## Eastern Corridor Segments II and III

Combined Linwood/Eastern Interchange and US 50/Red Bank Interchange Focus Area

# US 50/RED BANK CONNECTIVITY

**Figure I-25B**  
**DUAL WESTBOUND TURN LANES**  
**AND DUAL NORTHBOUND THROUGH LANES**

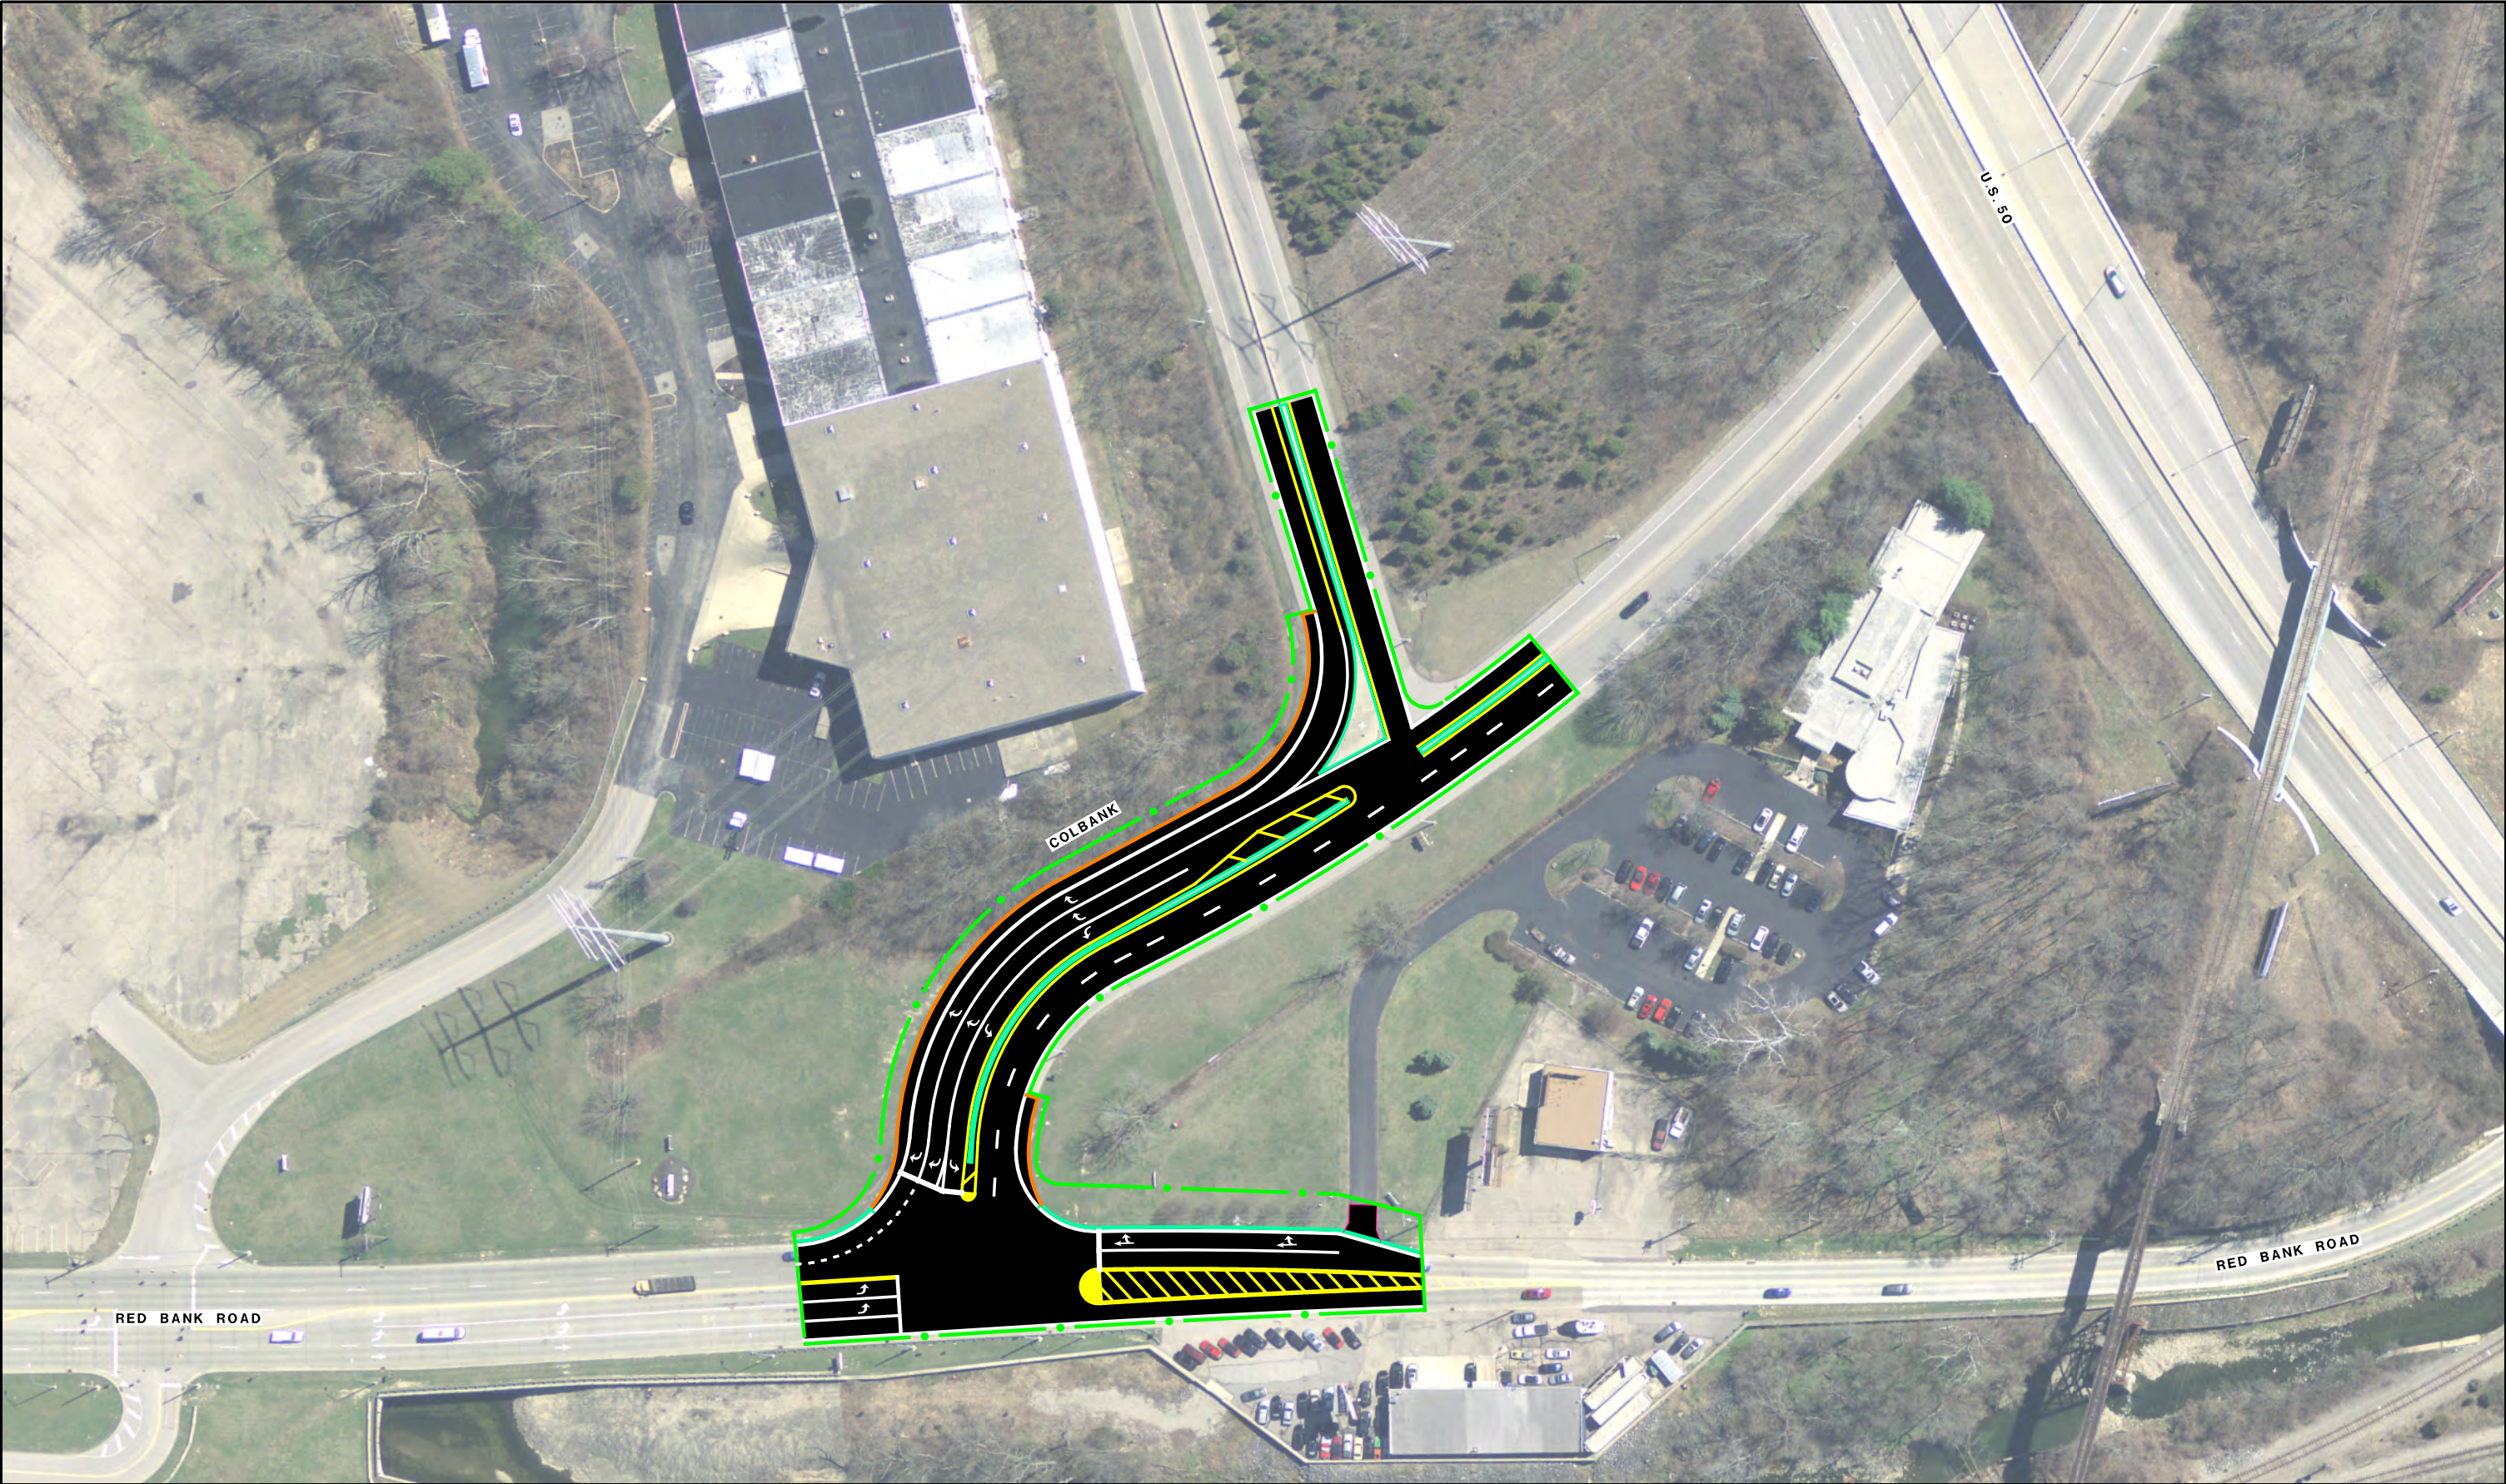
- The committee discussed installing a traffic signal to stop the northbound movement at the intersection of Colbank and US 50 ramp and provide a turn arrow so that drivers turning left from Colbank to the westbound US 50 ramp don’t have to stop a second time but could move continually through the intersection (similar to the existing intersection at Glenway and Glenhills Way). The signal could be equipped with a sensor to display an arrow only when the queue is long.
- The committee discussed whether or not two travel lanes were needed on the ramp to eastbound US 50 past the Colbank/US 50 ramp intersection. Restriping could reduce the lanes to one if it’s warranted.
- No additional comments received following the 9/7 meeting.

- The needs of bicyclists should be considered as part of this concept.
- No additional comments received following the 5/22 meeting

- Committee members felt that this concept was a good, simple solution for the challenges in this area.
- The public also appeared to like or be neutral toward this concept; see Public Feedback Ratings Summary, next page.

- Include concept in the Implementation Plan as a high priority.

**Figure I-25C**  
**RELOCATE RED BANK/COLBANK INTERSECTION**

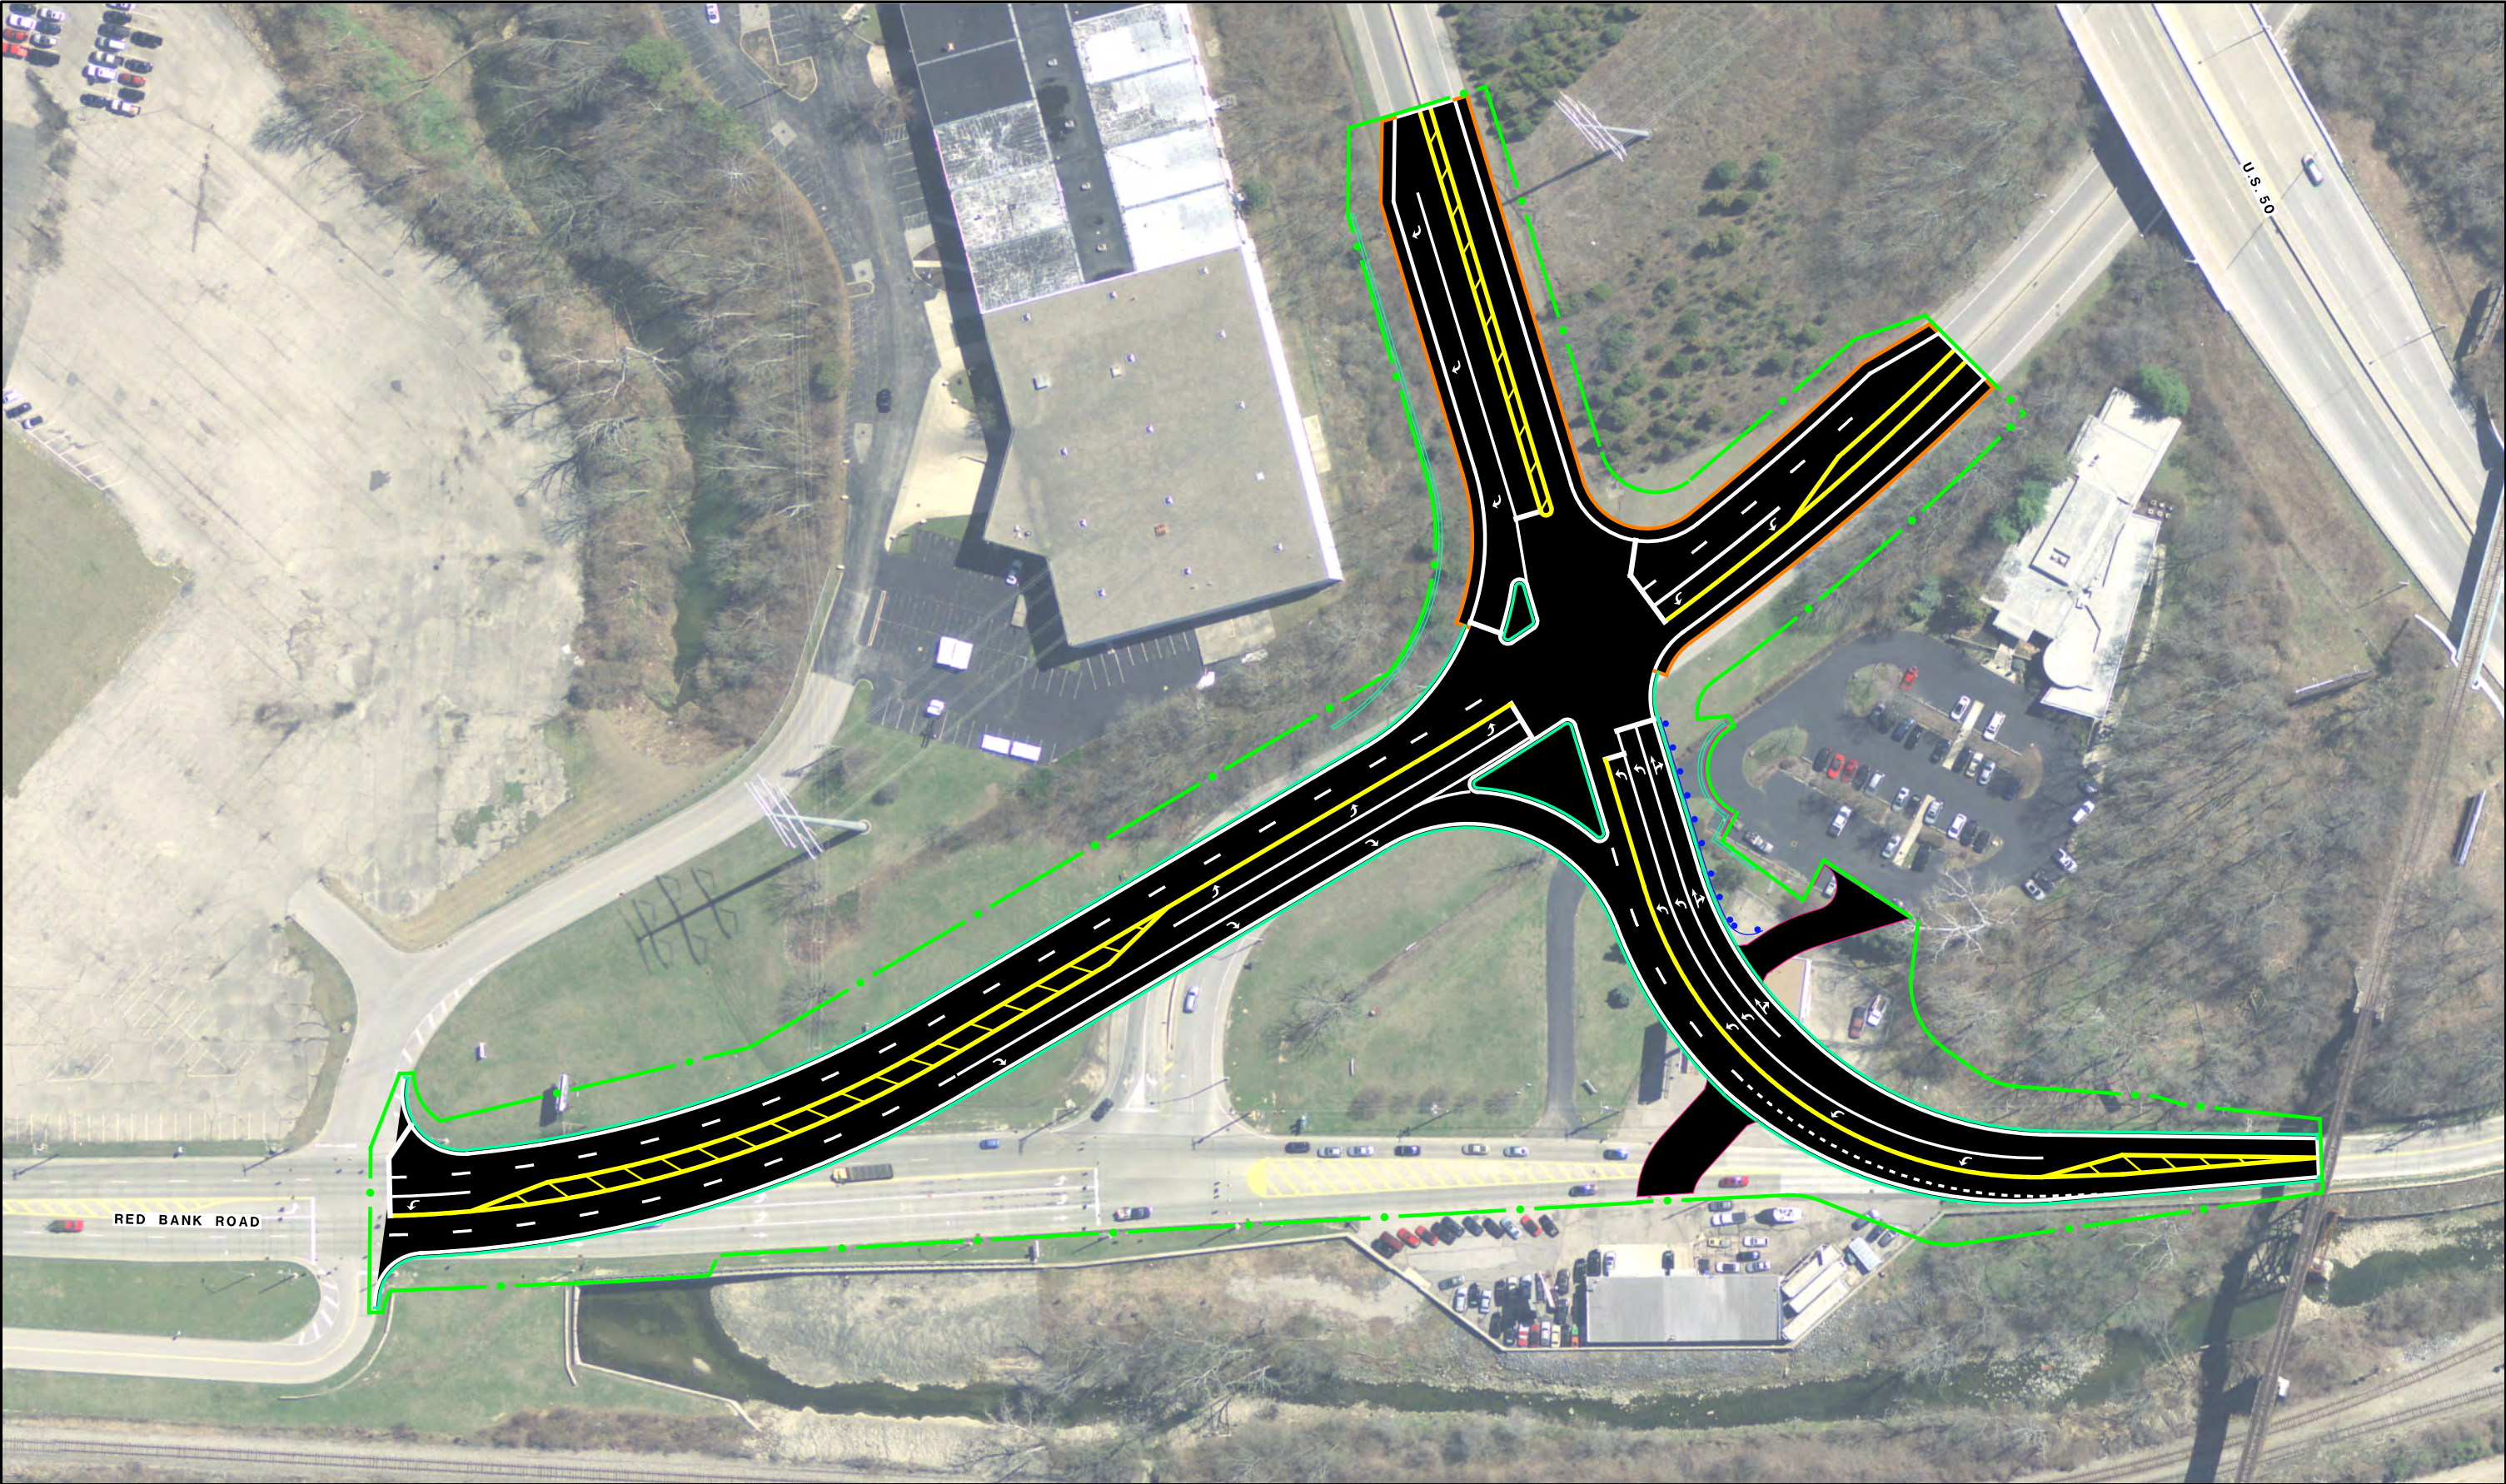
- The reconfigured intersection would better support current and future traffic volumes.
- Initial analysis indicates that, as proposed, this concept would result in:
  - An 80 percent decrease in morning peak-hour delays.
  - A 50 percent decrease (approximately) in evening peak-hour delays.
- The concept would require vehicles traveling north on Red Bank Road (from Wooster Pike) to turn left at the new intersection to continue traveling on Red Bank Road.
- Constructing the approach to the new southwest leg of the new intersection would require:
  - Eliminating a building along Red Bank Road, west of the Lawyers Title of Cincinnati building located at 3500 Red Bank Road.
  - Crossing under the railroad trestle has a width constraint that limits the concept.

- Mariemont does not support eliminating the intersection. Multiple traffic routes currently allows for options for vehicle and truck traffic from businesses.

- This concept is an alternative to others designed to improve operations at the Red Bank/US 50 interchange: I-25b, X-4a, X-4c-2, X-4d and X-4d-1.
- This option combines two intersections into one.
- Functionally, this concept works well to improve traffic delays; however, access to two businesses is compromised, and it would require relocating one business.
- No additional comments received following the 9/7 meeting.

- No further study. The benefit provided by this concept is comparable to concept I-25b, which is less expensive and has fewer impacts.
